CITY OF ALBUQUERQUE

**RE: Blake's Lotaburger #75
4121 Coors Blvd NW
Grading & Drainage Plan
Engineer's Stamp Date: 03/06/20
Hydrology File: G11D069D**

Based upon the information provided in your resubmittal received 03/12/2020, the Grading & Drainage Plan is approved for Building Permit and for action by the DRB on Site Plan for Building Permit.

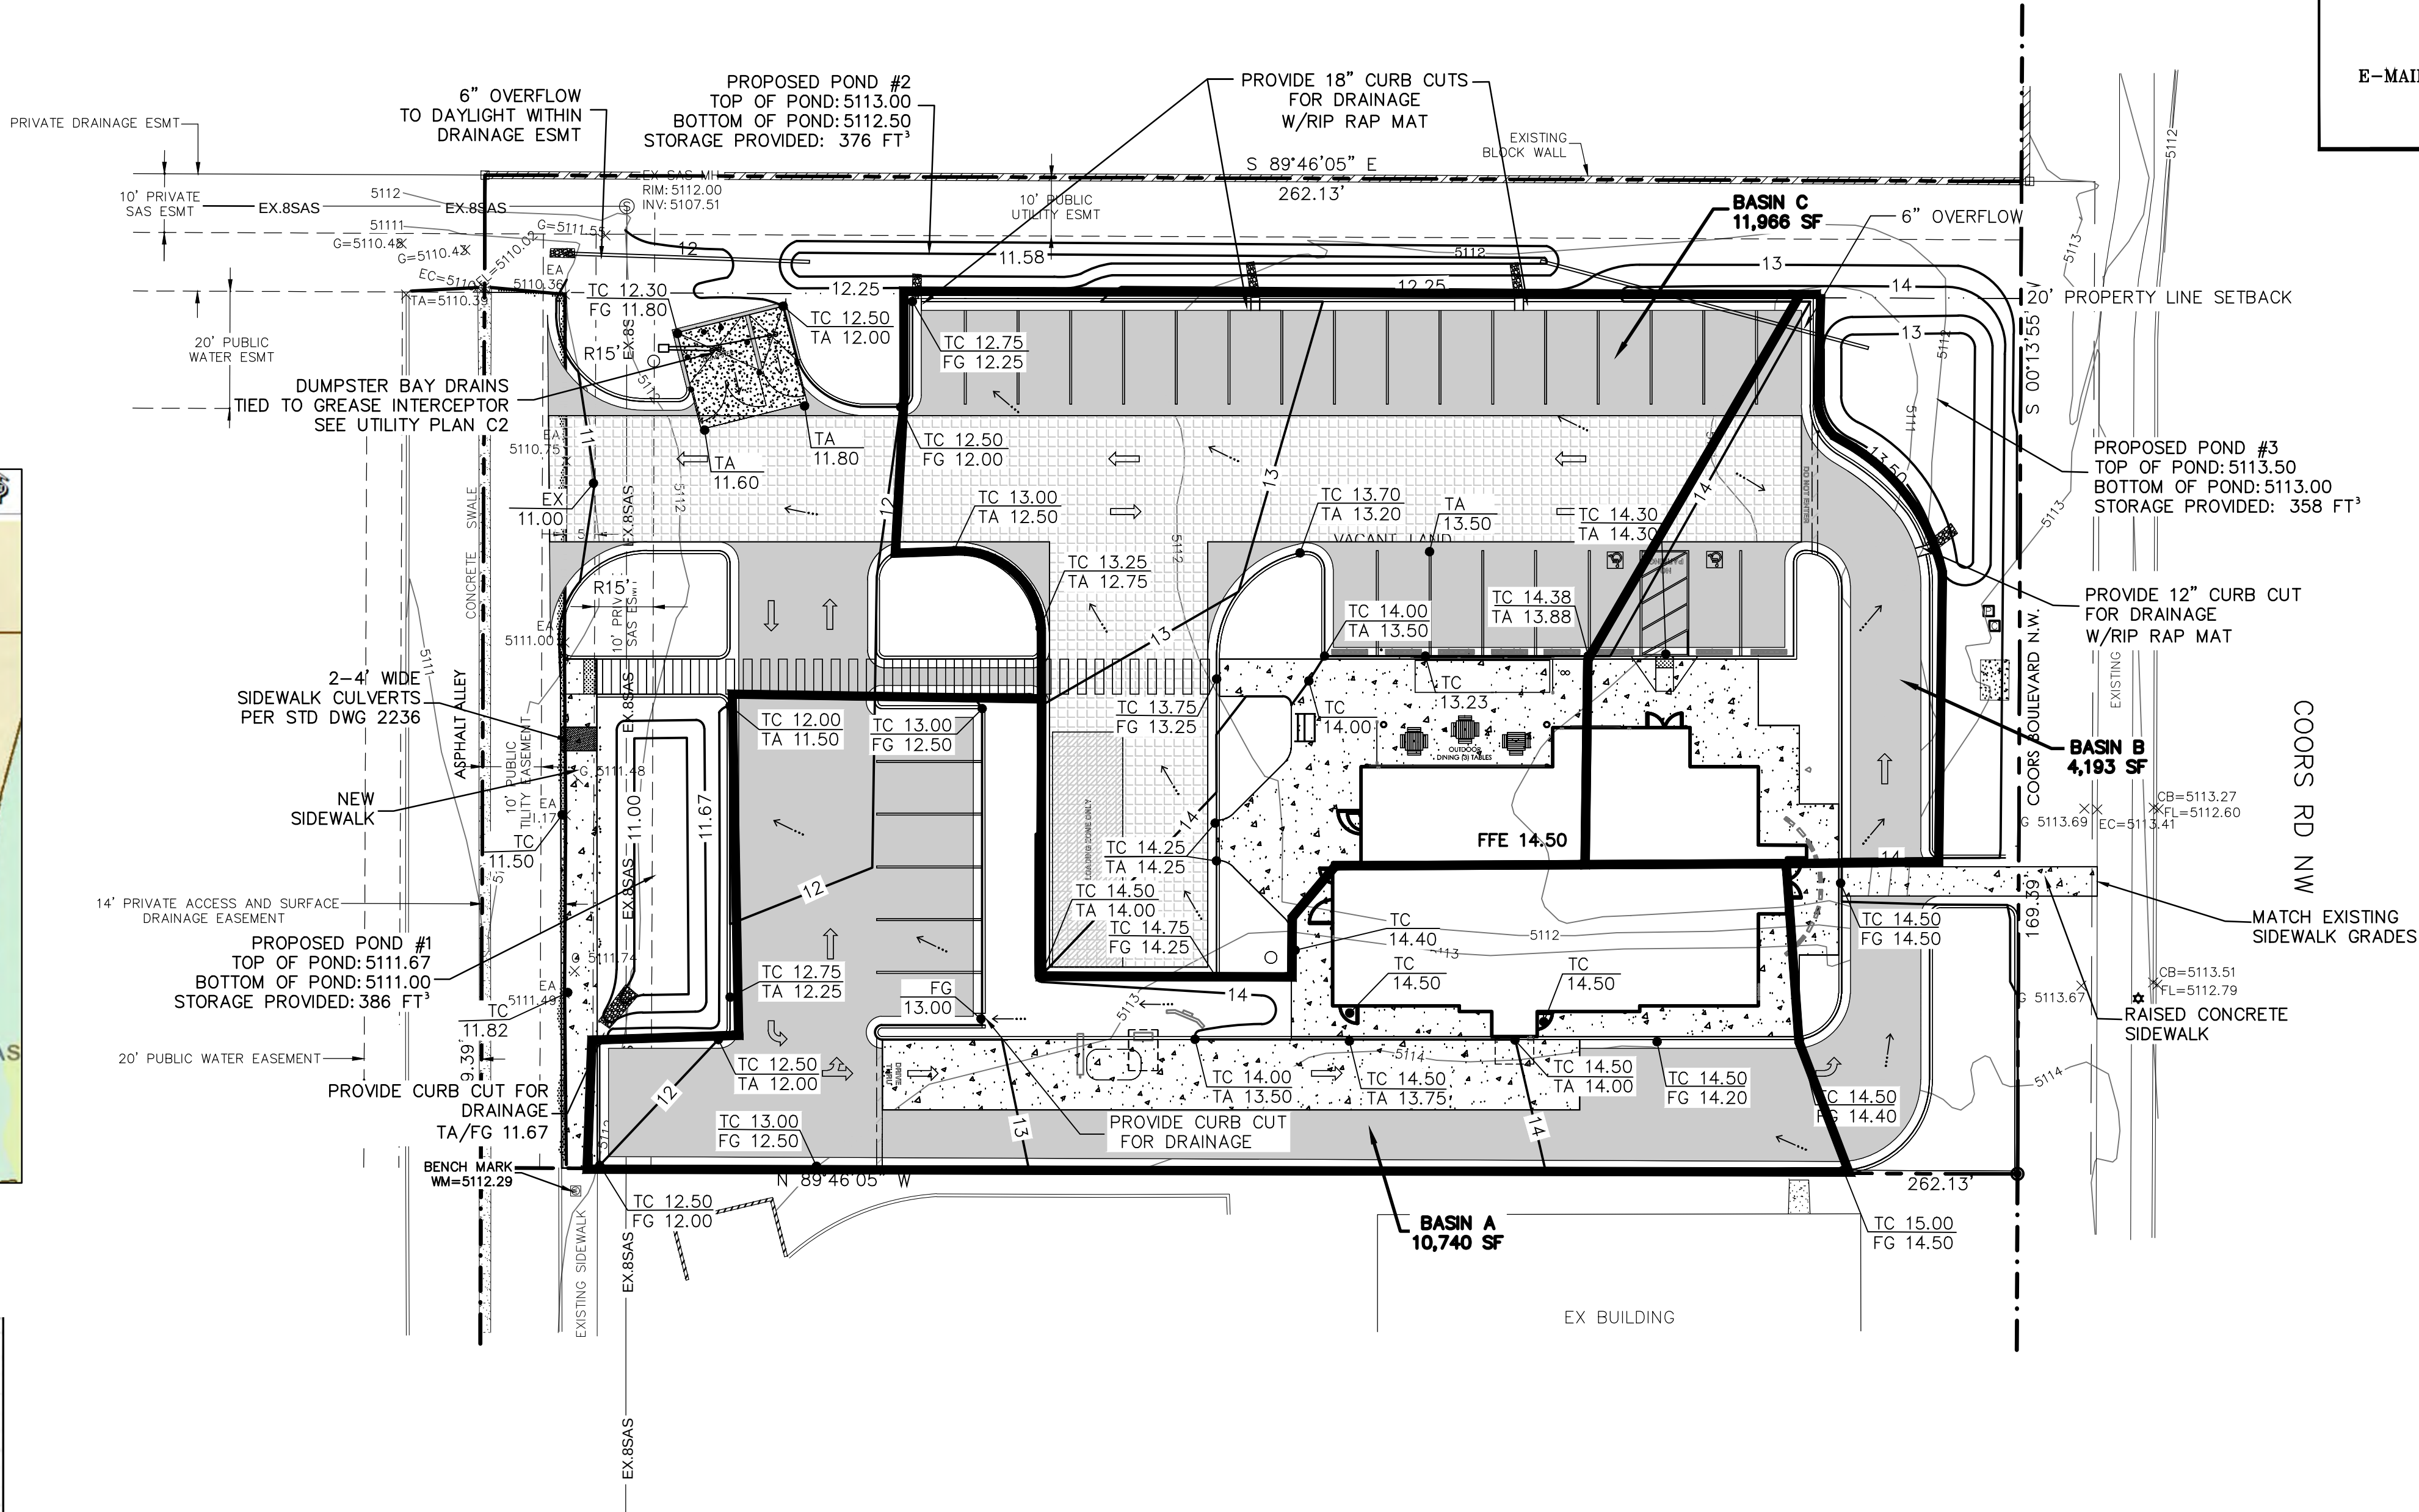
Also as a reminder, please provide Drainage Covenant for the stormwater quality ponds per Chapter 17 of the DPM prior to Permanent Release of Occupancy. Please submit this on the 4th floor of Plaza de Sol. A \$25 fee will be required.
